Subject: Project name Additions and Alterations, Majmudar Residence
 Project site address 12119 Dusk View Court, Clarksville, MD
 Permit # B22002088 SDP # _____
 Other information pertinent to this project _____

From: Silvast, Zackary
Sent: Wednesday, August 3, 2022 4:26 PM
To: Ronald Johnston
Cc: mukesh@starglobalventures.com; Williams, Jeffrey
Subject: RE: Permit # 22002088, Additions and Alterations, Majmudar Residence, 12119 Dusk View Ct., Clarksville

From: Silvast, Zackary
Sent: Thursday, June 16, 2022 4:01 PM
To: ron@rarchitect.com
Subject: Regarding building permit # - B22002088 (12119 Dusk View Ct)

Plot Plan

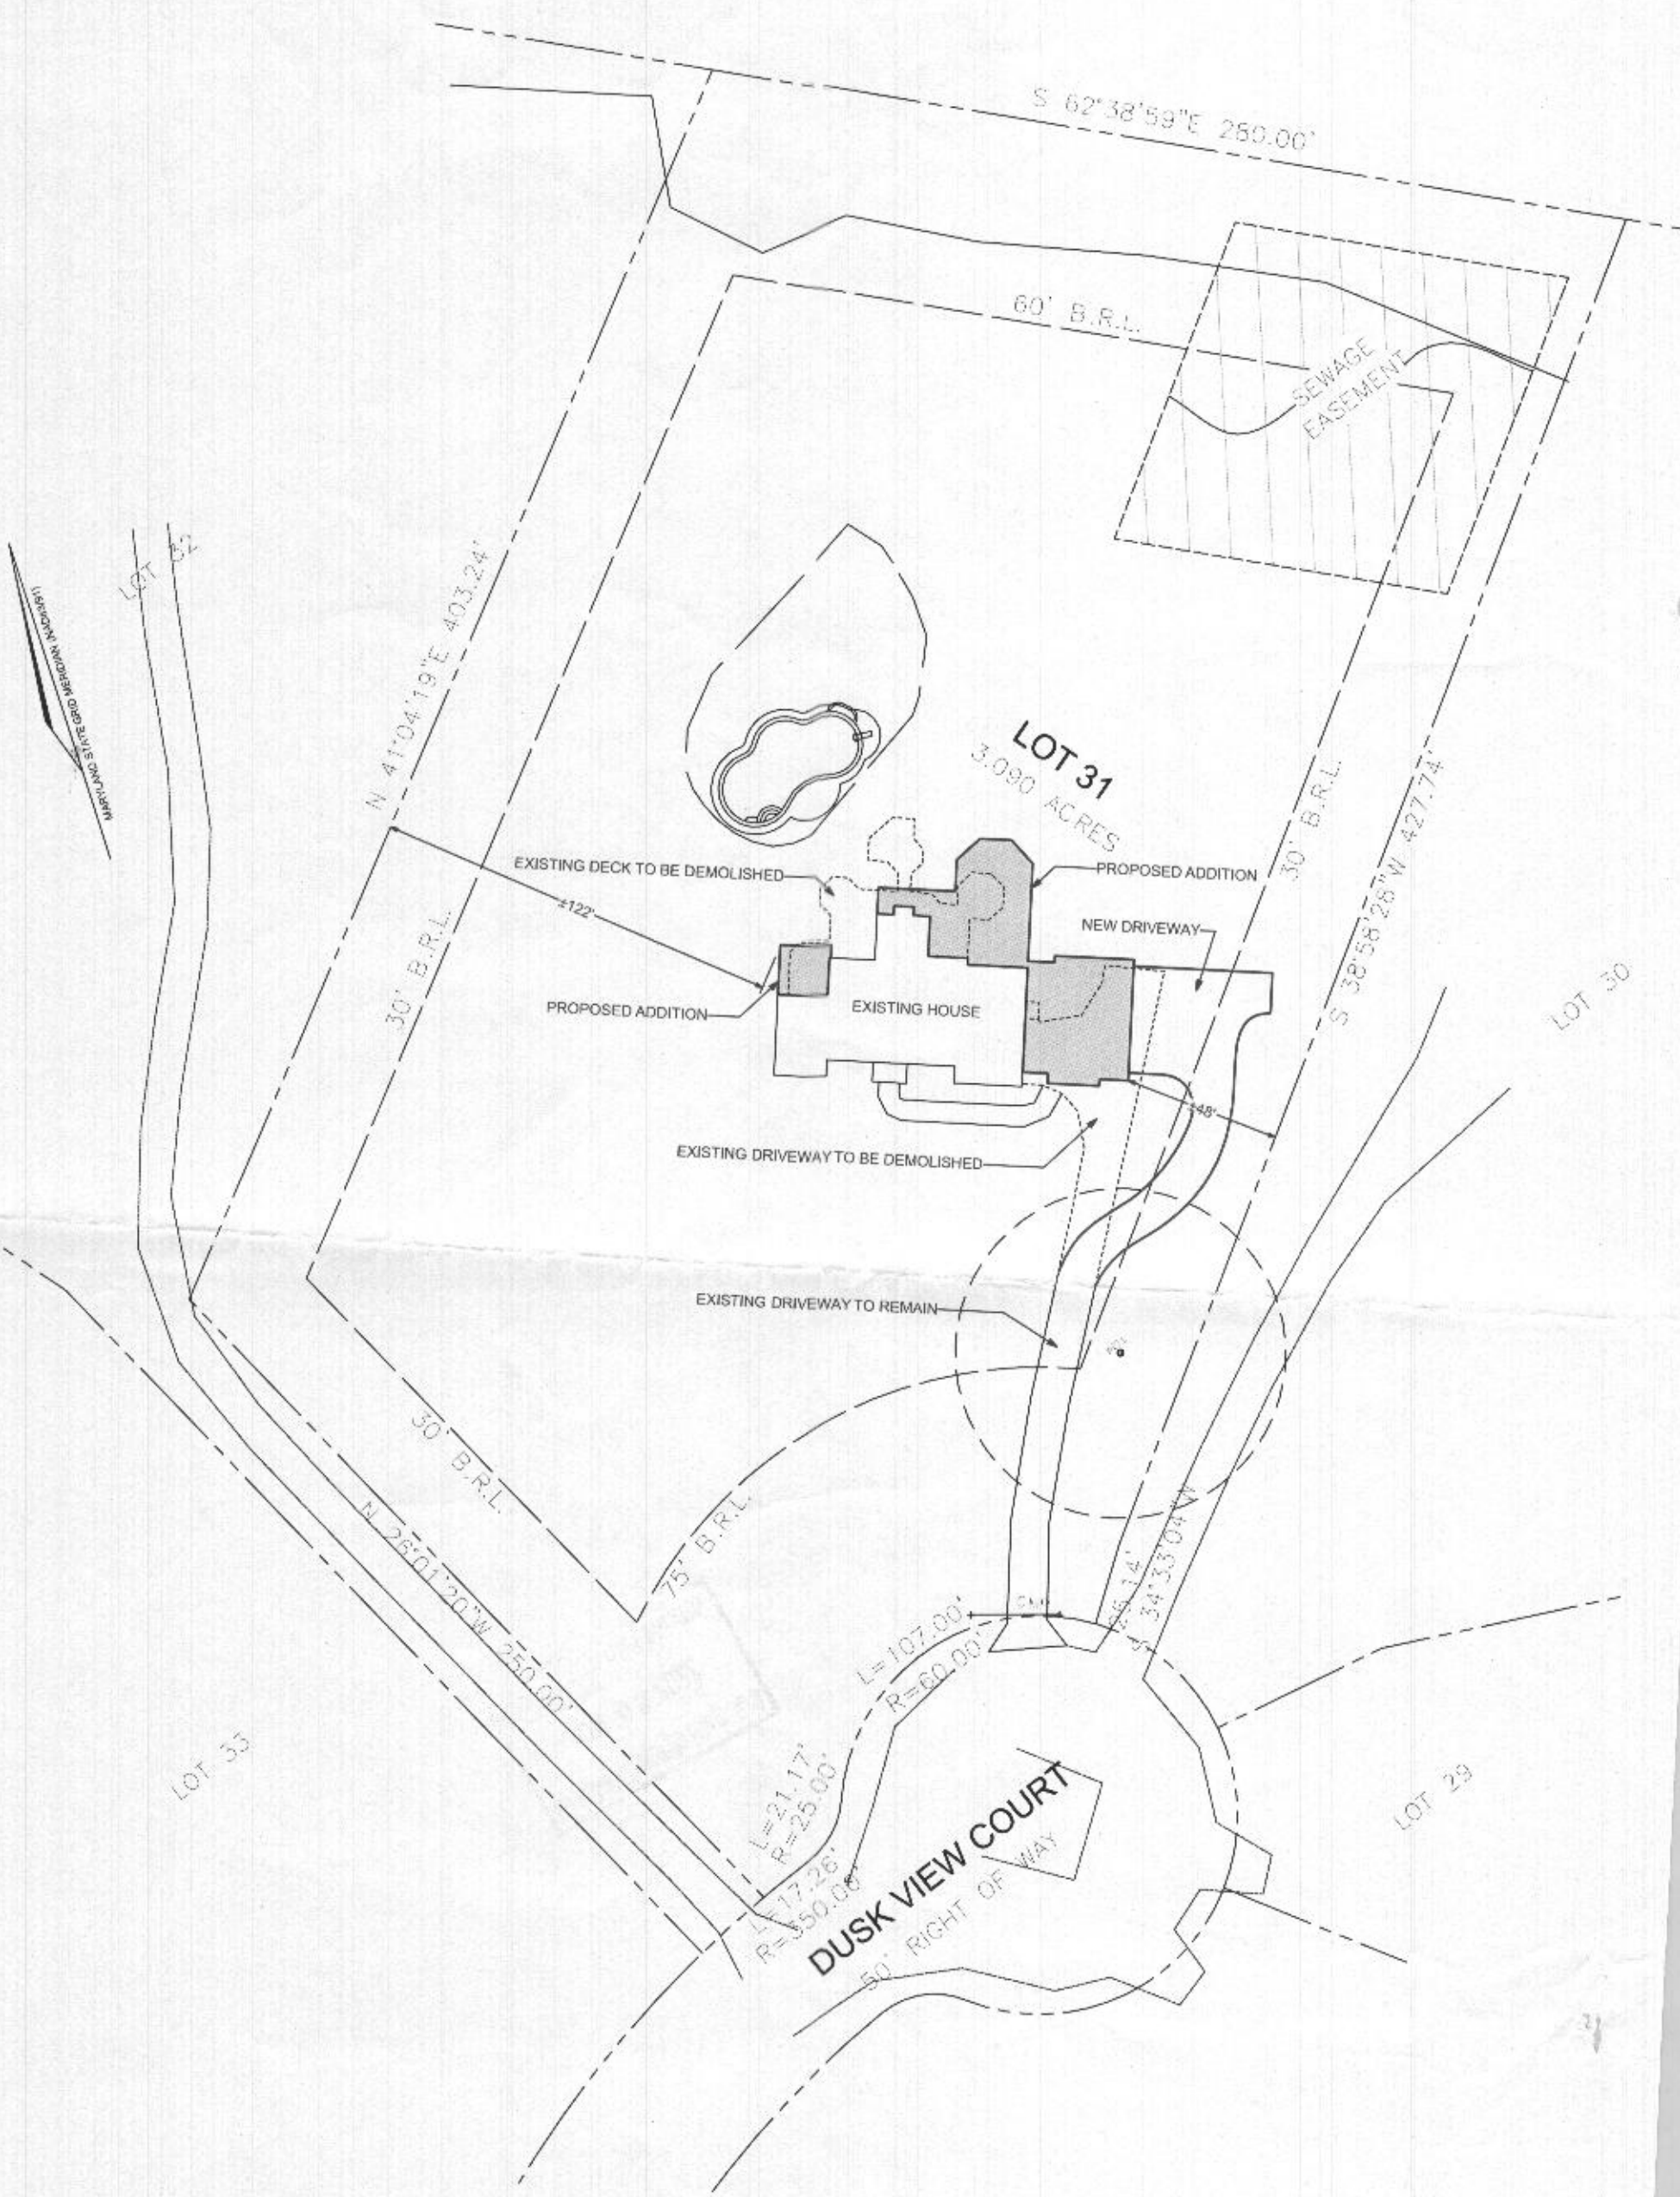
The reviewed plans are showing a proposal of a 6 bedroom house. While the existing septic drainfields are adequate for this increase from 5 to 6 bedroom capacity, the current septic tank needs to be upgraded to a 2000 GAL septic tank. The health department will require an updated plot plan showing the current septic tank location and the current invert elevation from the house to the top of the septic tank elevation. All of the septic piping should also be shown on this plan as one piece of the addition looks like it will negatively impact the existing piping from house to septic tank. The new plot plan should be drawn to scale, with a 1" = ? engineer's measurement. If you have any other questions or concerns, feel free to contact me via e-mail.
